CONWAY
HISTORIC DISTRICT COMMISSION
STAFF REPORT

5:30 pm • November 25, 2019 • City Hall

II.A 2035 INDEPENDENCE AVENUE - NEW SINGLE-FAMILY RESIDENCE

II.B EXTERIOR MODIFICATIONS - 332 OLIVER STREET

Front elevation

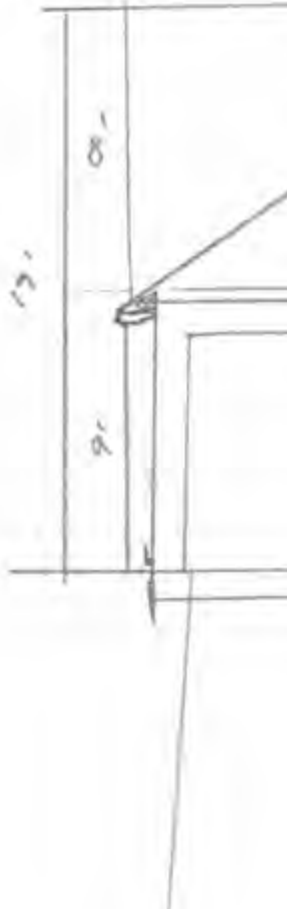
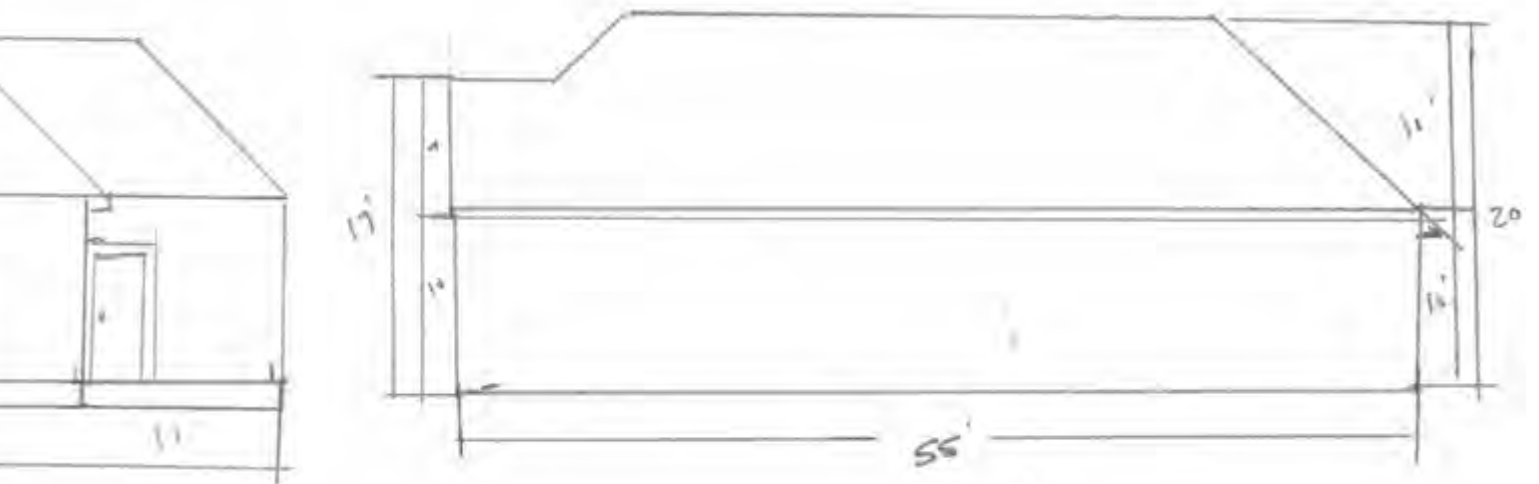
A covered front porch with a 6' depth is proposed. Windows will require true divided lights.

Siding is proposed. Fascia and soffits should be required to be of wood construction.

It's unclear as to what roofing material is proposed. Architectural shingles shall be used.

1. The oak tree and gum tree in the front yard shall be maintained through construction. Proper tree protection shall be executed during construction.
2. Require true divided light windows if 4 over 4 windows are included as proposed. 1 over 1 windows may also be allowed.
3. Require fascia and soffits to be finished with wood construction.
4. HVAC equipment be placed in a manner to minimize its visibility from the street.
5. Architectural shingles shall be used for roofing material.
6. The applicant will provide revised and corrected plans to the Planning Director for review and approval prior to issuance of building permits.

FRONT ELEVATION

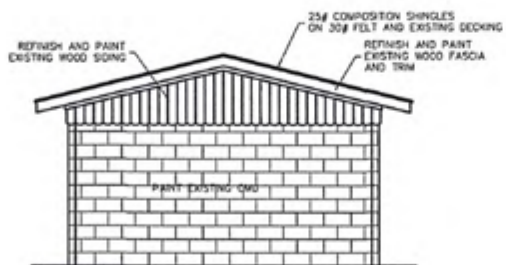
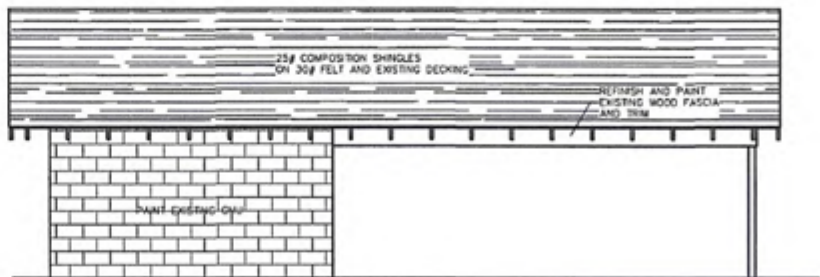
The applicant is proposing to extend the existing concrete driveway apron past the sidewalk. This pad would effectively function to create a front yard parking area. Recommend a two-concrete strip driveway be required back to the existing carport instead of the proposed concrete pad.

The depth of the porch will not be altered. The detailing on the upper façade is appropriate. If the existing windows are removed, true divided lights will be required.

Siding is proposed as Hardieboard. Fascias and soffits should be required to be of wood construction.

The addition is located at the rear and proposed to be flush with the main structure. Recommend requiring the addition be slightly stepped inside the exterior façade wall to indicate a distinction between the original structure and the addition.

1. The proposed rehabilitation and addition shall be clad in either wood siding or cement fiber siding (Hardie Board).
2. The applicant construct a two-concrete strip driveway be required back to the existing carport instead of the proposed concrete pad.
3. If the existing windows are removed, true divided lights will be required.
4. Planting of one canopy tree in the front yard.
5. Require fascia and soffits to be finished with wood construction.
6. HVAC equipment be placed in a manner to minimize its visibility from the street.
7. The applicant will provide revised plans to the Planning Director for review and approval prior to issuance of building permits.

Applicant provided sketch

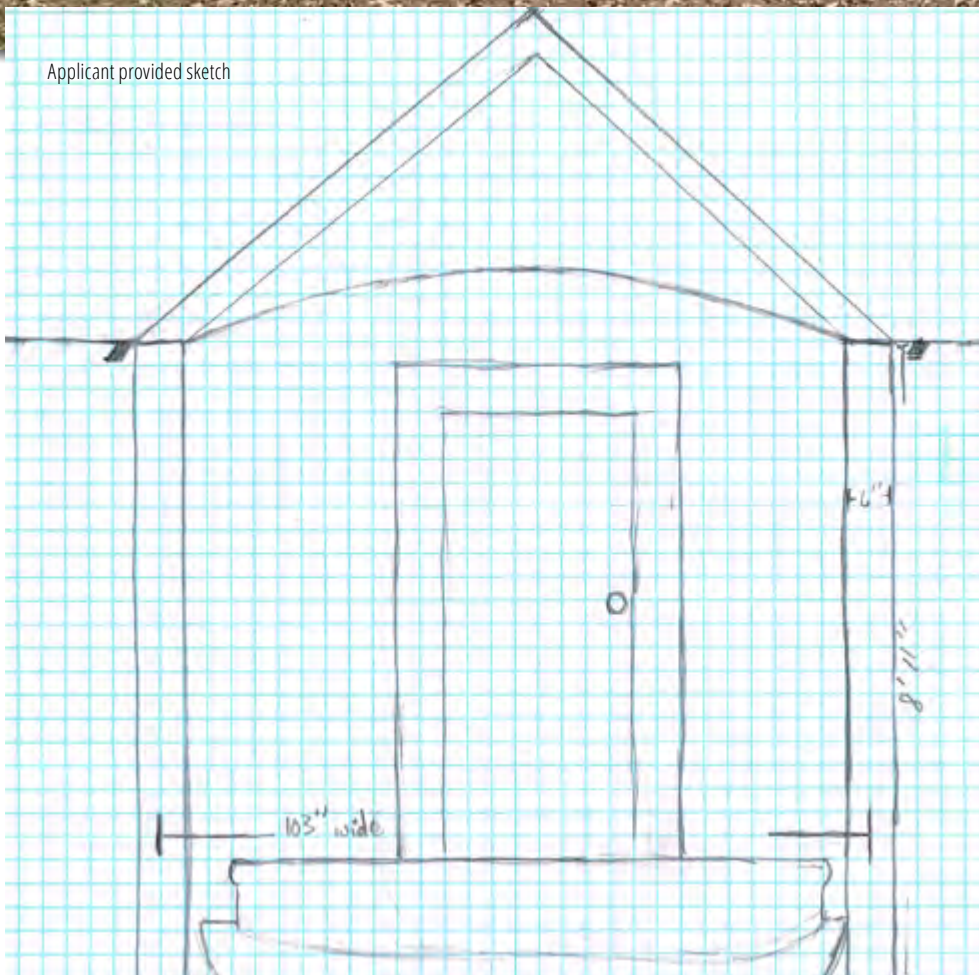
A covered front portico with a 5' depth is proposed.

Siding is proposed. Fascia and soffits should be required to be of wood construction.

1. Materials shall be used that are consistent with the materials of the existing structure. Wood siding shall be used.

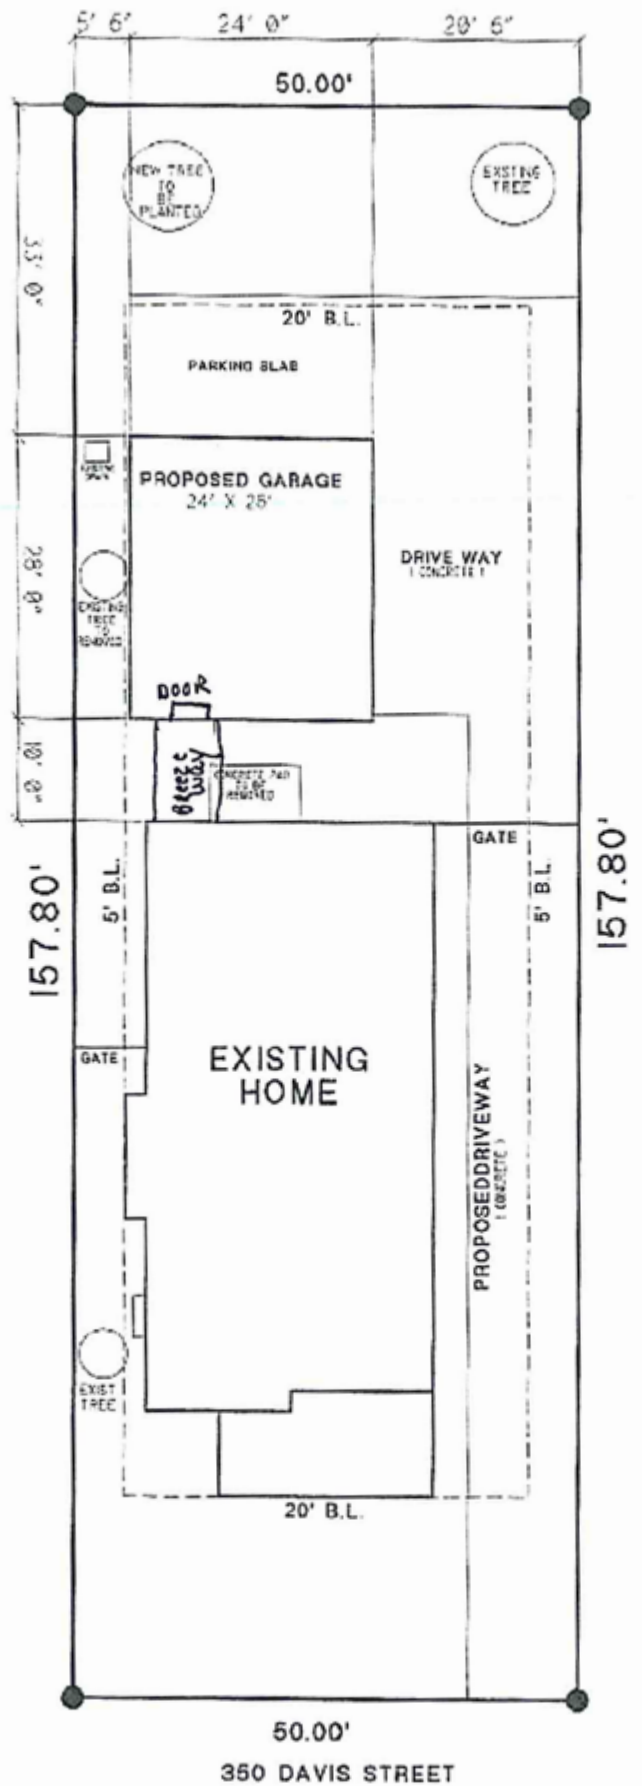
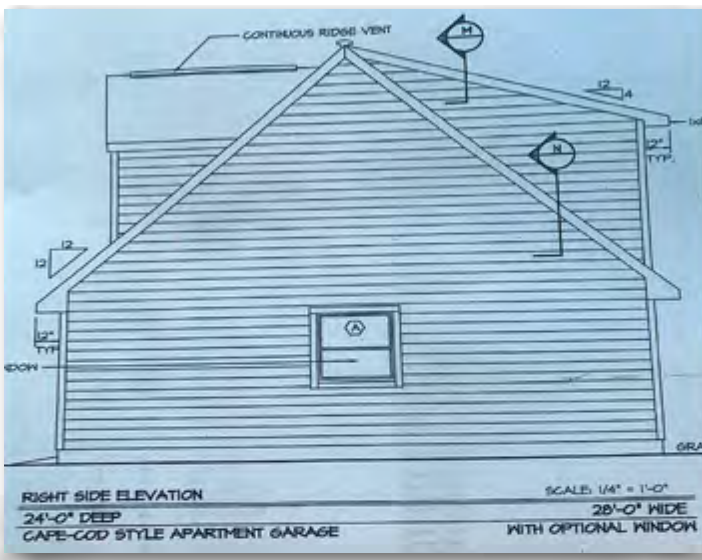
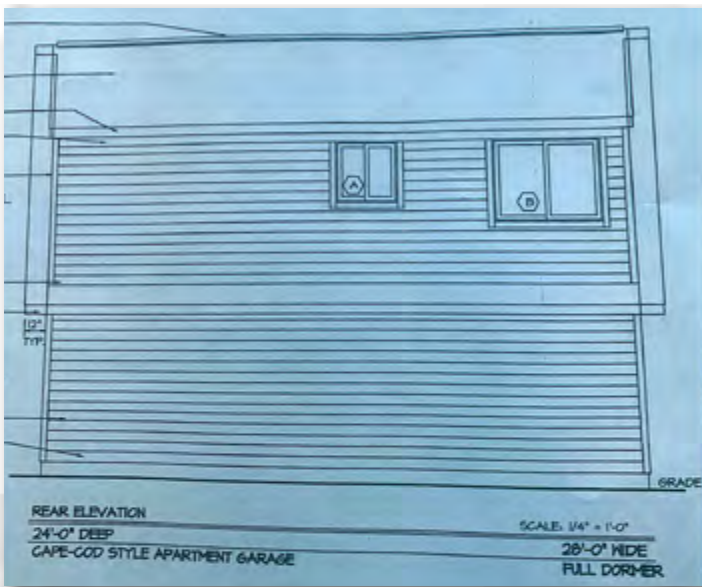
While the addition is located to the rear of the existing structure, it is proposed at two stories with a total of 1,200 square feet. As proposed, the addition would be a more dominant feature of the site than the existing residence. The structure would be visible from the street.

While the footprint of the addition is roughly 600 square feet, the total area of the addition is only 300 square feet less than the existing structure. The scale of the addition is inconsistent with guidelines of the overlay district.

The proposed addition is 2 stories. Existing structures in the surrounding area are all single story.

The front façade of the addition meets this requirement however the remaining sides fall short of minimum 25% requirement for windows.

No information has been provided indicating proposed materials. The existing house appears to be clad with wood siding. Any additions should be constructed with compatible materials including wood siding or Hardieboard/LP Smartside type siding.

Given the proposed height and the overall size of the addition, it's likely that it will become a dominant feature of the property. The addition will be visible from the street and will represent one of the only 2-story structures in the surrounding area.

Master site plan

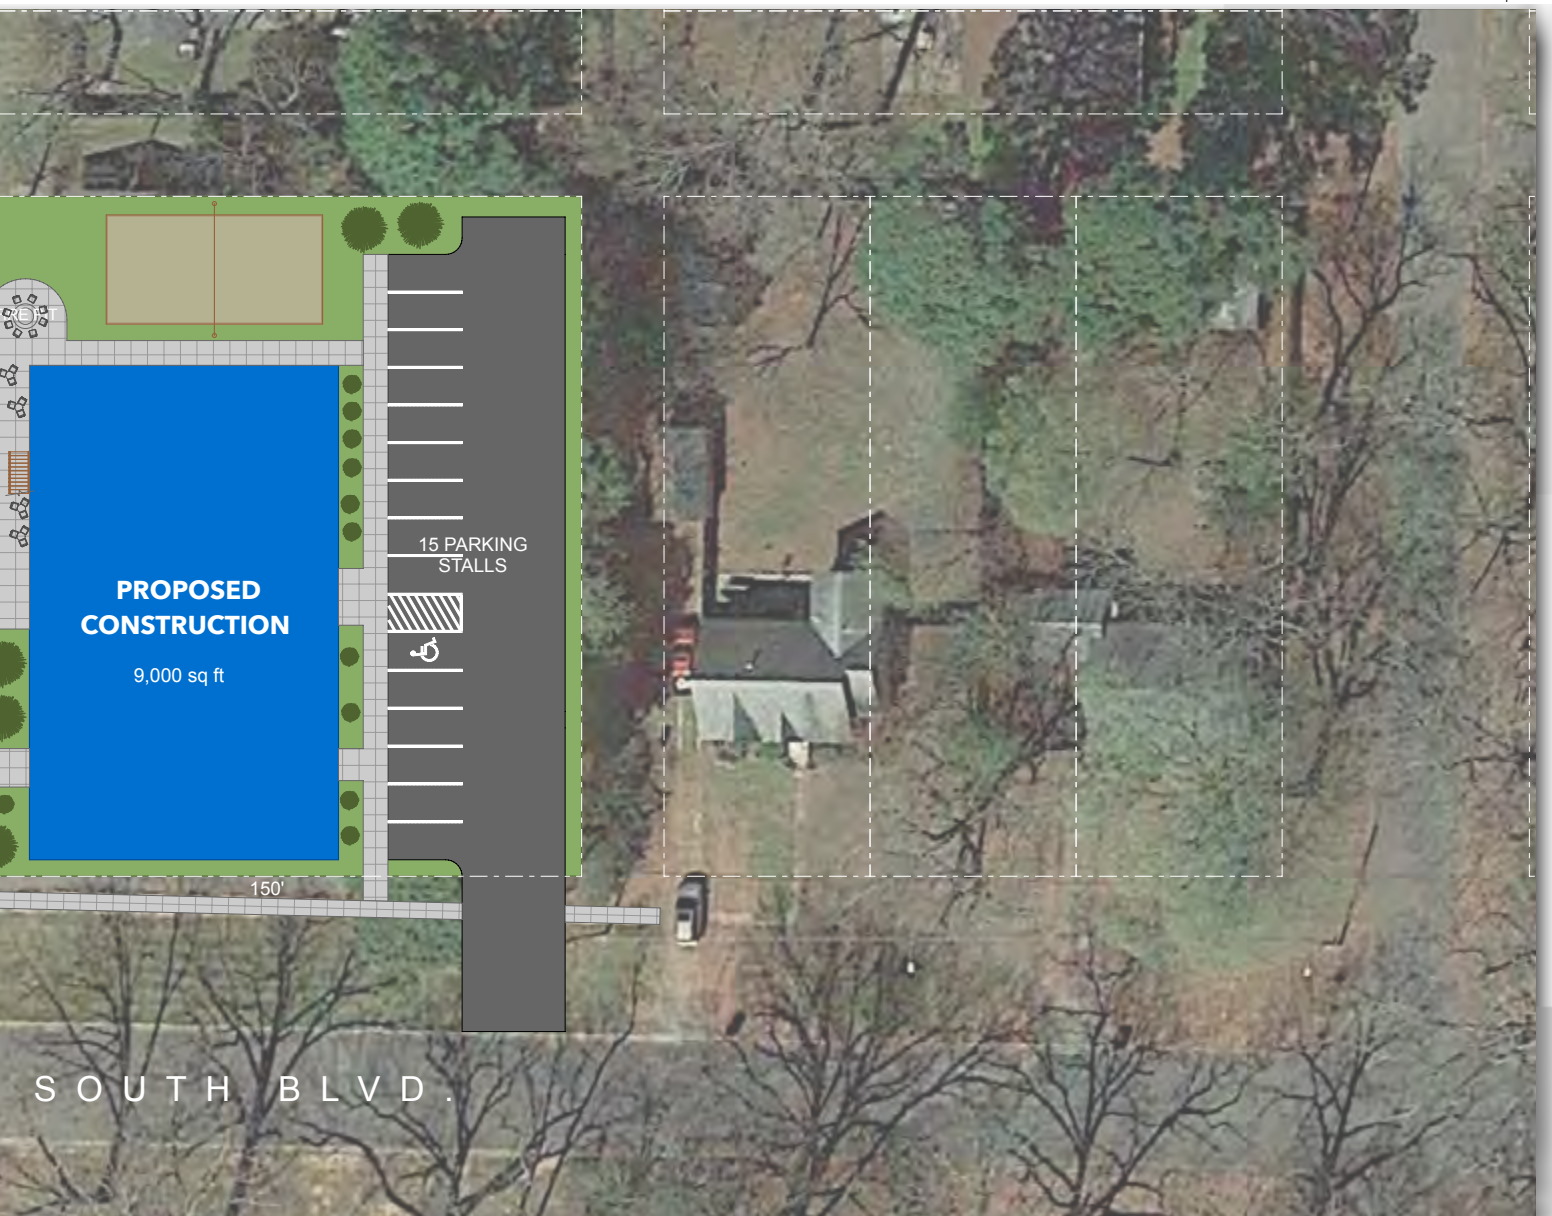
The function of the structure necessitates a primary entrance off of Baridon Street. Such entrance is properly distinguished with an accompanying patio area. Setbacks for the structure are narrow and appropriate. The structure addresses South Blvd in a limited way, but is a function of the structure's use. Recommend requiring additional architectural detailing on the South Blvd façade to create proper visual interest toward the street.

Proposed parking is appropriately located. Recommend requiring a low brick wall to screen parking areas along South Blvd.

10. Require a low brick wall to screen parking areas along South Blvd.
11. Provide revised plans to the Planning Director for approval prior to issuance of the Certificate of Appropriateness.

**Exterior Elevations - 2
Story**

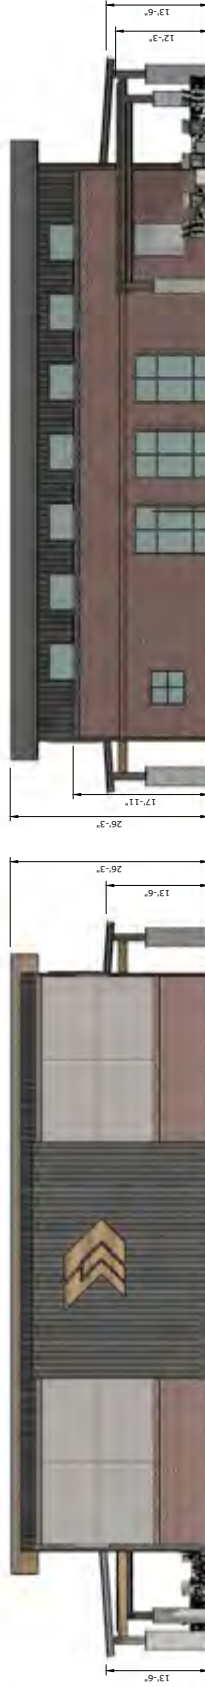
The applicant is proposing use of EIFS on the south end of the building. This is not appropriate. The structure has no windows facing South Blvd and does not properly address the street. The use of metal siding on the façade facing South Blvd is also inappropriate.

Roof forms and materials are appropriate for the intent of the structure. Recommend requiring screening of the rooftop air conditioners to deflect noise generated by the units toward the north.

- Replacement of the EIFS with brick and use of soldier course of contrasting brick and corbelling to create additional visual interest.
- False windows or similar glazing comprising between 25-40% of the façade wall along South Blvd.
- Replacement of the metal siding along South Blvd with an alternative architectural feature such as a wood slat wall with limited voids. Such voids could be used with appropriate lighting to create a unique visual architectural feature.
- Applicant provide more detail on the types of metal siding proposed for the structure's main entrances. Standard R-panel should not be permitted.

1. Require additional architectural detailing on the South Blvd façade to create proper visual interest toward the street.
2. Require replacement of the EIFS with brick and use of soldier course of contrasting brick and corbelling to create additional visual interest.

3. Require false windows or similar glazing comprising between 25-40% of the façade wall along South Blvd.
4. Require replacement of the metal siding along South Blvd with an alternative architectural feature such as a wood slat wall with limited voids. Such voids could be used with appropriate lighting to create a unique visual architectural feature.

5. Require applicant provide more detail on the types of metal siding proposed for the structure's main entrances. Standard R-panel should not be permitted.

6. Provide plans for external lighting of the facility.
7. Require screening of the rooftop air conditioners to deflect noise generated by the units toward the north.
